Well Name: POKER LAKE UNIT 22-3 BS	Well Location: T25S / R31E / SEC 22 / SWSW /	County or Parish/State:
Well Number: 112H	Type of Well: CONVENTIONAL GAS WELL	Allottee or Tribe Name:
Lease Number: NMNM0070707A	Unit or CA Name:	Unit or CA Number: NMNM07016X
US Well Number: 3001553896	Well Status: Approved Application for Permit to Drill	Operator: XTO PERMIAN OPERATING LLC

Sundry ID: 2769548

Type of Submission: Notice of Intent      Type of Action: APD Change

<b>OPERATOR'S NAME:</b>	XTO Permian Operating LLC
<b>WELL NAME &amp; NO.:</b>	Poker Lake Unit 22-3 BS 112H
<b>LOCATION:</b>	Sec 22-25S-31E-NMP
<b>COUNTY:</b>	Eddy County, New Mexico

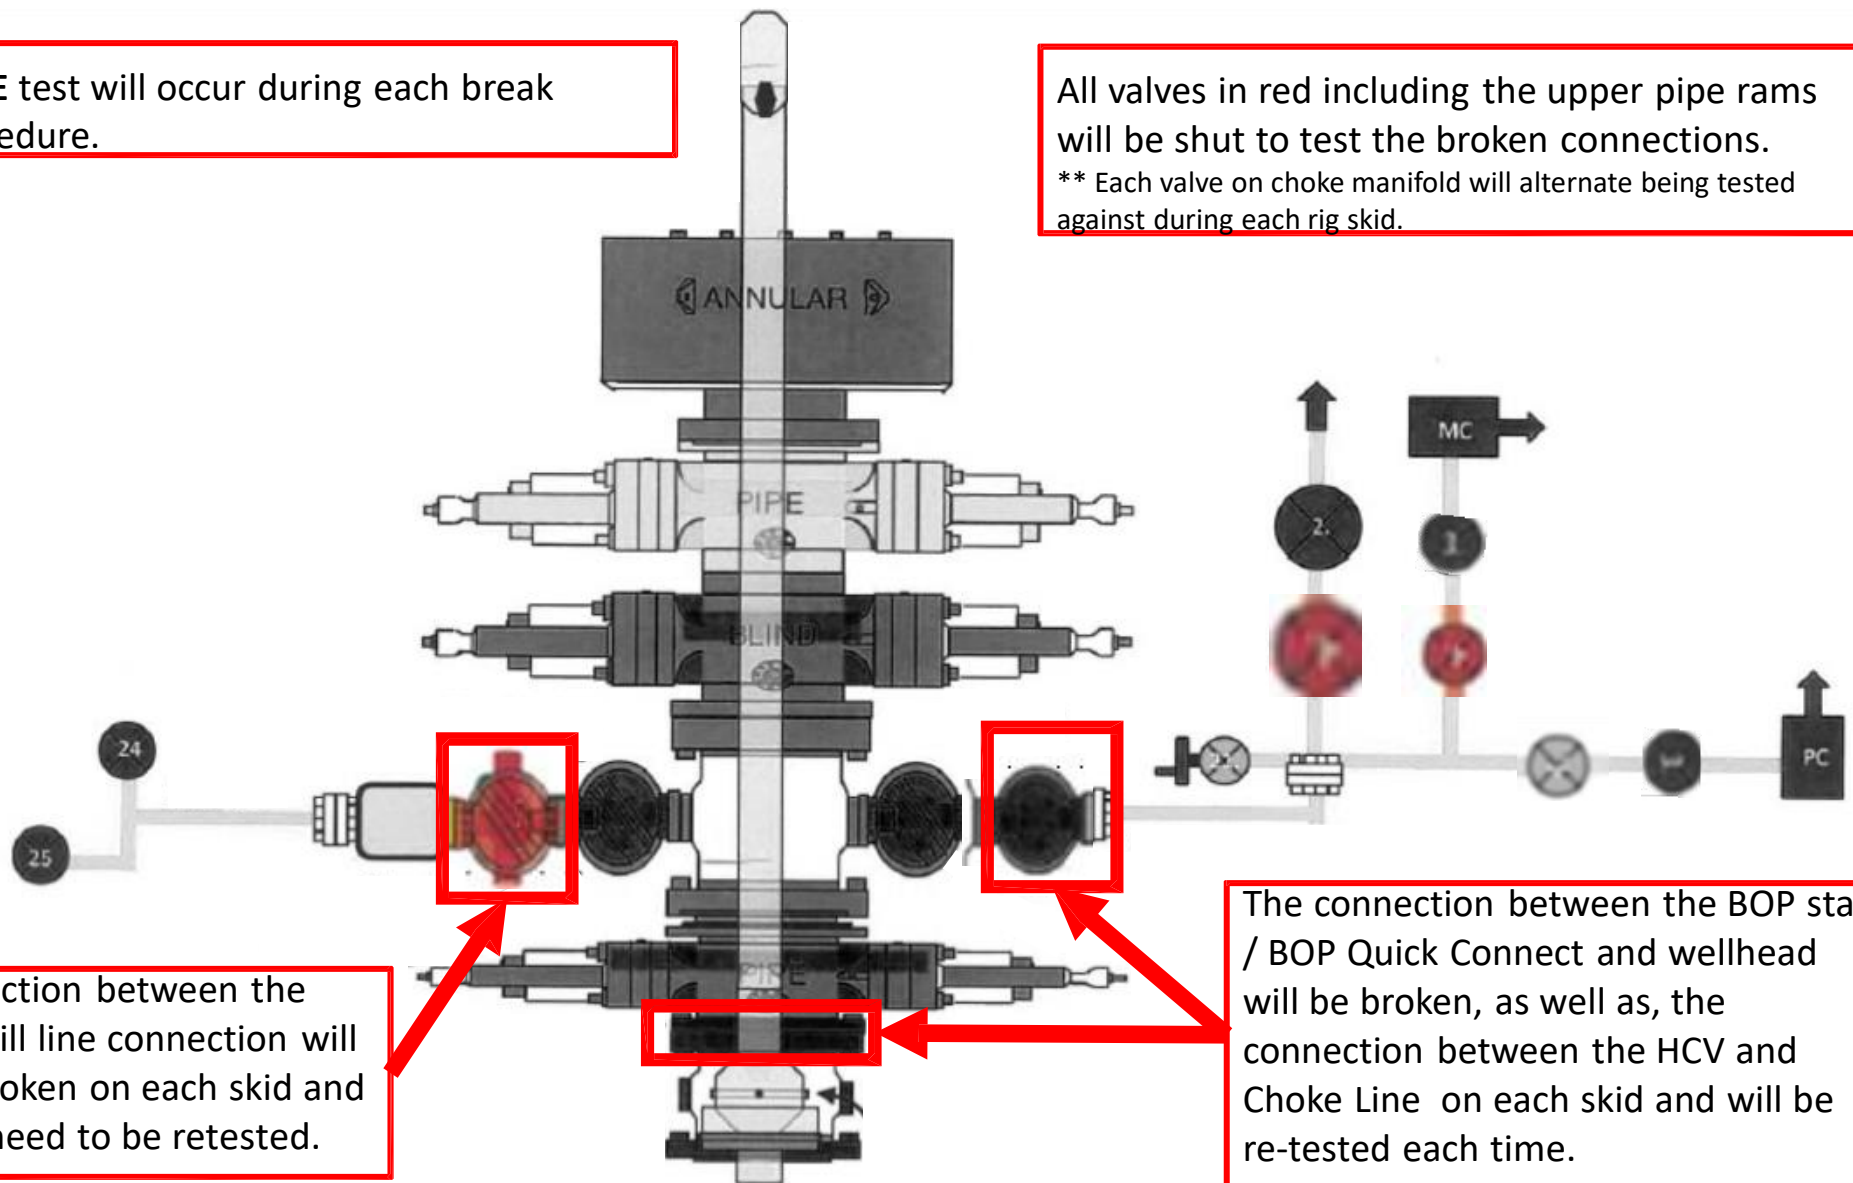
All valves in red including the upper pipe rams will be shut to test the broken connections.  
\*\* Each valve on choke manifold will alternate being tested against during each rig skid.

The connection between the HCV and kill line connection will **NOT** be broken on each skid and does not need to be retested.

The connection between the BOP stack / BOP Quick Connect and wellhead will be broken, as well as, the connection between the HCV and Choke Line on each skid and will be re-tested each time.
